Certificate of Appropriateness

628 N. BROADWAY

East Side Commercial Historic District

PTS ID 109558 COA Replace rear glass block windows

Two rear, alley facing windows to be replaced.

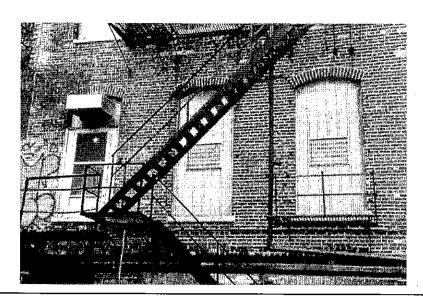
Description of work In conjunction with renovations on the second floor of this building, applicant proposes to replace glass block windows located on rear alley elevation.

Windows at the rear of this building have been altered over time. Some have been converted into door openings that access the adjacent fire escape. Some have been blocked down with wood or infilled with glass block. The two new windows will replace two windows that have glass block and will consist of fixed clear glass in aluminum frames of dark bronze color. The windows will be 103 inches by 47-1/2 inches in size to fit the openings and have a horizontal bar to simulate a double hung window. The manufacturer is Kawneer and the spec sheet is attached.

Wood windows are typically required as replacements on historic buildings. However, in this instance the original windows have already been replaced and the windows face an alley in mid-block and are not visible from the right of way. This is no way sets precedence for replacement windows at other locations but is specific to this application only.

Construct as submitted.

Replacement windows.

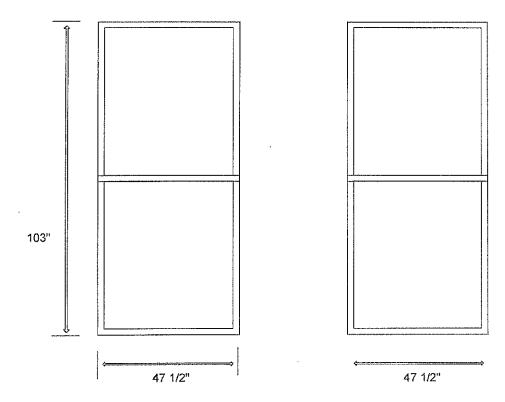
Propose to replace two existing glass block windows on 2nd floor east facade with dark bronze aluminum storefront framing and fixed clear glass.. Framing dimensions are 4-1/2" deep with a 2" sightline. A horizontal piece of framing will be added at the midpoint of the opening to simulate the appearance of doublehung windows.
